Regarding: MARTIN ROUNDABOUT UPGRADE

Development Description: The proposed measures at the upgraded signalised junction include: provision of public transport priority measures, provision of cycling facilities and associated pedestrian enhancements and traffic calming measures.

On behalf of the committee please find below our observations on the above application. *We would welcome an opportunity to meet with planners and engineers of Galway City Council and the National Transport Authority to explore our concerns and alternative proposals in greater detail.*

Figure 2. Google satellite view screen grab showing obvious desire lines not safely or conveniently catered for in the current design and which might be met by a combination of cycle by-passes and overbridges at the locations circled in red.

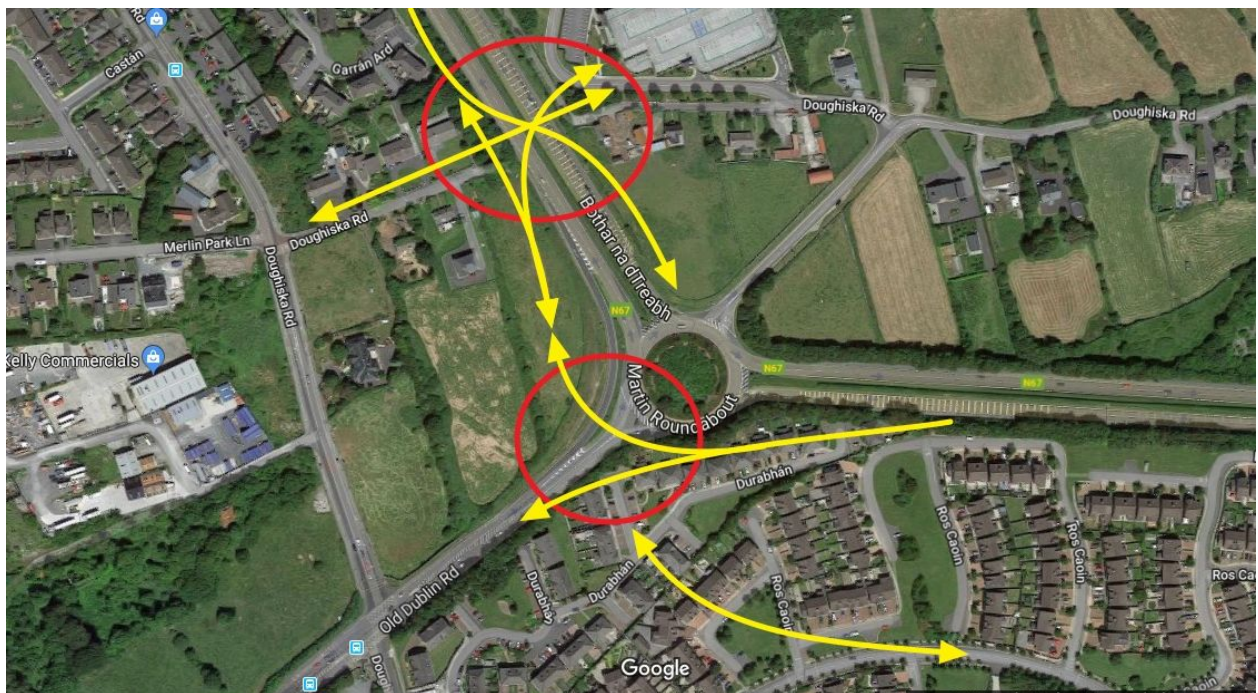
Desire line East-West: walking and cycling bridge over N67

There is an obvious desire line from Merlin/Doughiska along the minor road that was severed when the dual carriageway was built. A cycling compatible overbridge should be provided over the dual carriageway linking through to the Doughiska road. This will allow cyclists and pedestrians to avoid the main roads altogether. It would also link through to an obvious route to the city via Merlin Lane and so avoiding the Old Dublin Road which is not an inviting cycling or walking environment.

Figure 7: Proposed design features to cater to journeys and desire lines of cyclists and pedestrians. Proposed new links between housing estates and onto new cycling and walking infrastructure developments are indicated by yellow, dashed lines.

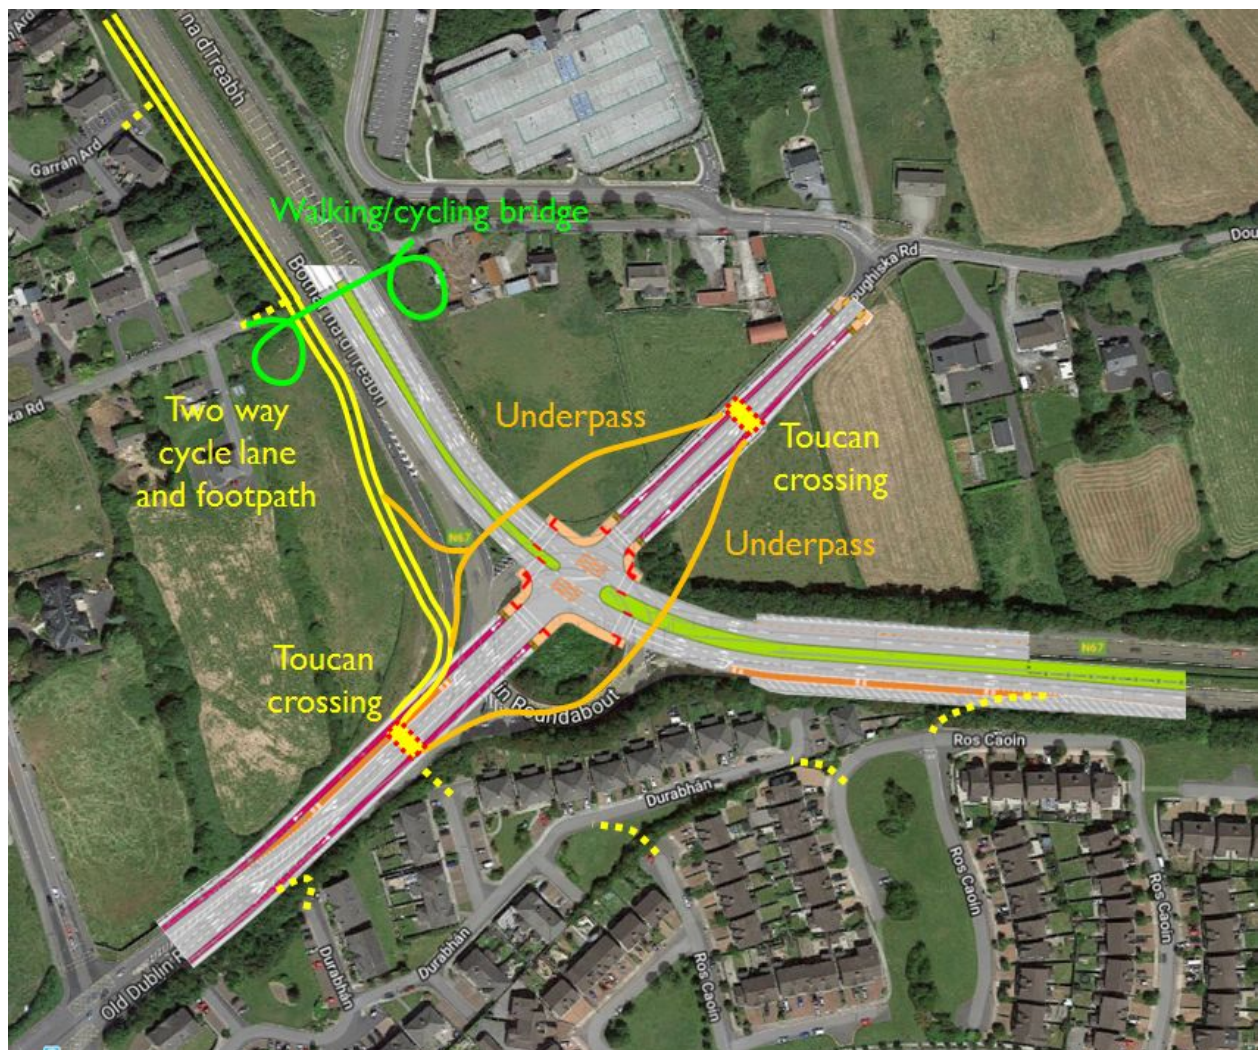
Facilitating safe transit through the Martin junction itself could be achieved with bridges as detailed above or through provision of underpasses (of sufficient quality). Along with appropriately placed crossing points, these would also facilitate right-turns from all arms of the junction.

Note also the provision of a left, slip-turn for walking and cycling coming from the Old Dublin Road turning north (alongside the N67).

Figure 9. Annotated junction design.

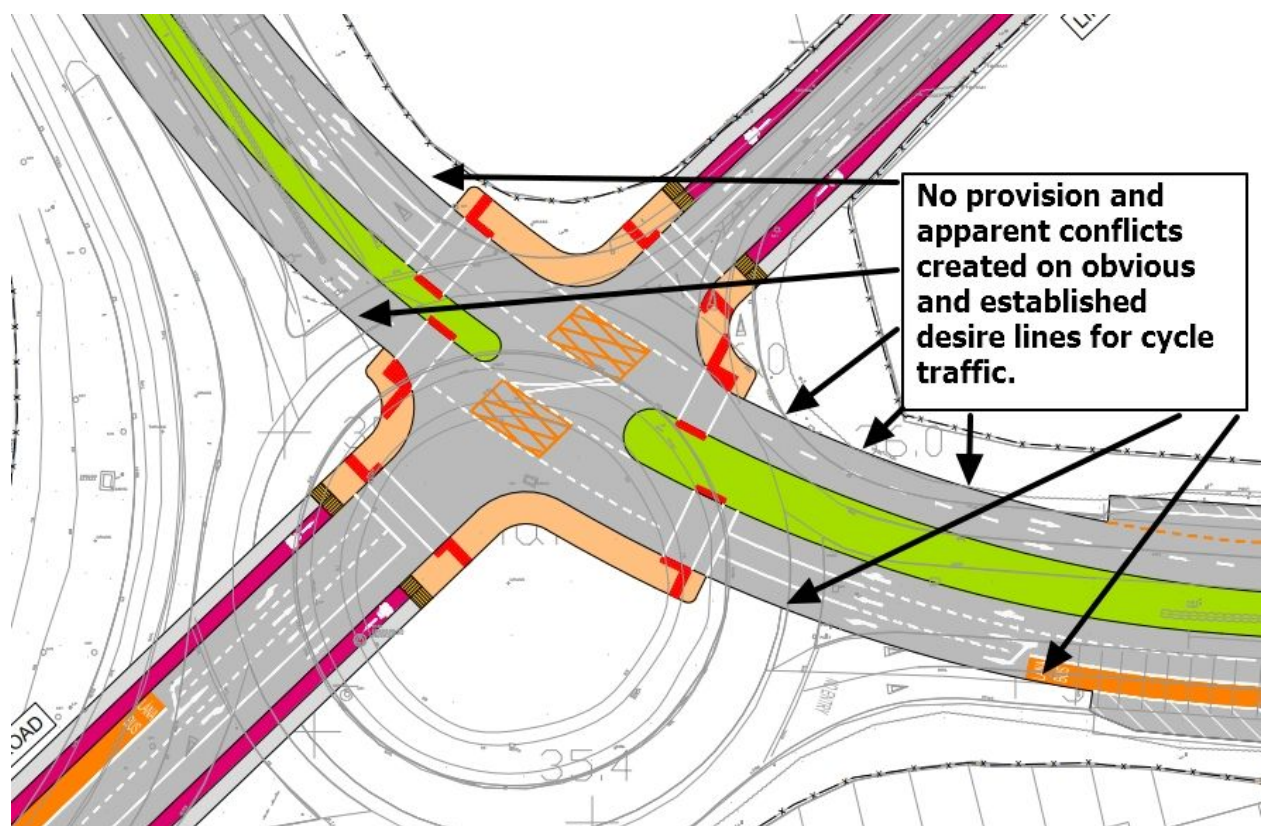
Cyclists arriving at the junction and intending to travel to Oranmore along the dual carriageway have not been catered for. If they face significant delays then some will ignore the proposed cycle facilities and stay on the main roadway. Regardless of how they make the turn, if standard lane widths (2m to 3.65m) are used turning cyclists will be put in conflict with heavy traffic as they pass through the junction. There is a need for a hard shoulder or spacious nearside lane widths (>5.0m)¹ particularly on the Oranmore arm outbound. It is questionable if cycle tracks should be used on a segment that delivers cyclists to or from dual carriageway hard shoulders. If a raised cycle track is used then the issue of how turning cyclists access it or leave it needs careful treatment.

The current design ignores the needs of cyclists coming from the Oranmore direction along the dual carriageway. Those heading for the city can be catered for using a left-bypass around the junction or through the estate at Durabhan/Ros Caoin. Those heading for Parkmore can be catered for by providing a second overbridge over the Old Dublin Road on the south side of the junction. This should link through into the Durabhan/Ros Caoin estates.

Figure 10. Extract from *Lancashire the Cyclists’ County* 2005, Parkin’s *Designing for Cycle Traffic* 2018 repeats the same advice. Coloured boxes added for emphasis.

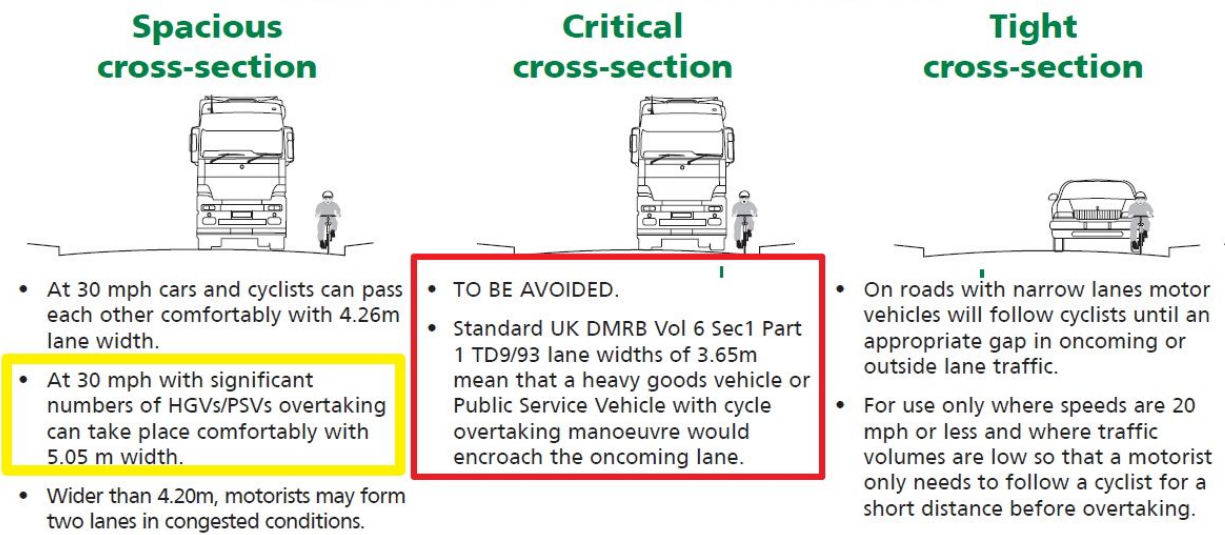
In the absence of detailed information on the design we recommend that any one-way cycle tracks or hard shoulders be a minimum of 2m wide. Any transitions where the cycle tracks leave or rejoin the main roadway should be smooth and should not require manoeuvres. The practice of mixing pedestrians and cyclists should be avoided at locations with a strong link function.

Figure 11. Extract from planning drawing showing cycle track transition creating conflict with people on foot and requiring 90 degree turns into, or out of, the main traffic lane at a junction on a bend.

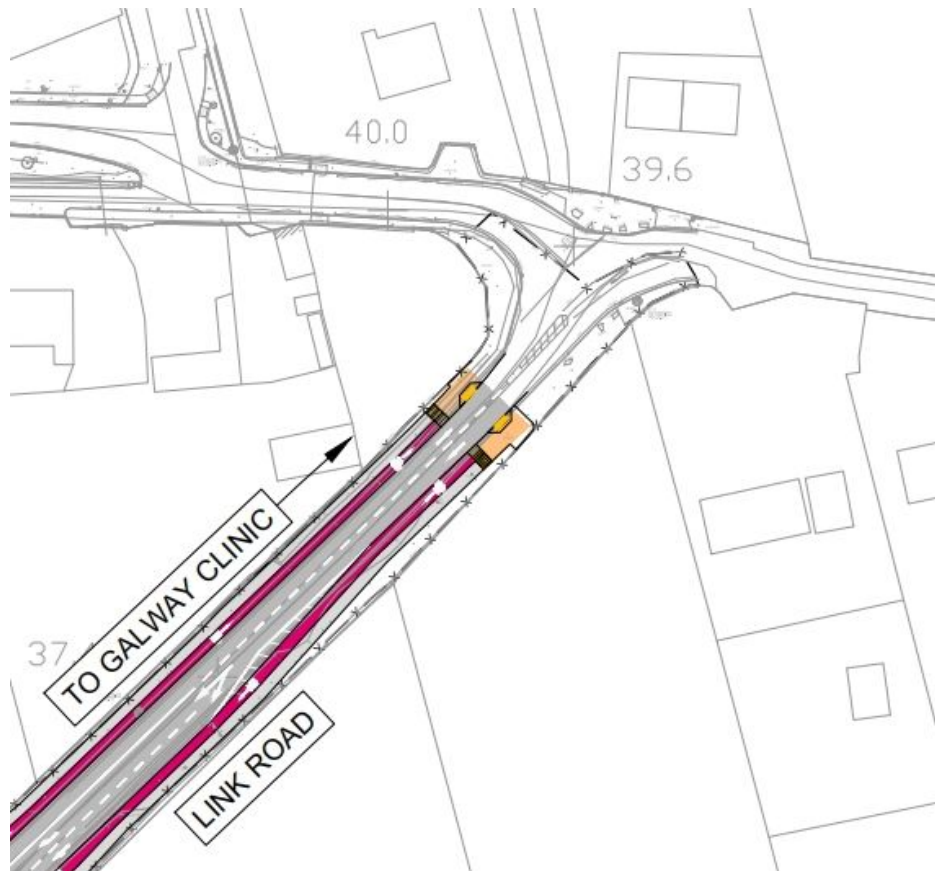
On the Galway Clinic arm for the junction the transition between the cycle track and the main roadway appears to be managed by placing cyclists in a conflict with both pedestrians waiting to cross and requiring an abrupt 90 degree turn into, or out of, the main traffic lane. This also occurs on a bend. If the cycle track is to merge with, or diverge from, the main traffic lane then this should occur well away from the bend, the junction, the crossing point and in a manner that does not require abrupt 90 degree turns into or out of the main lane.
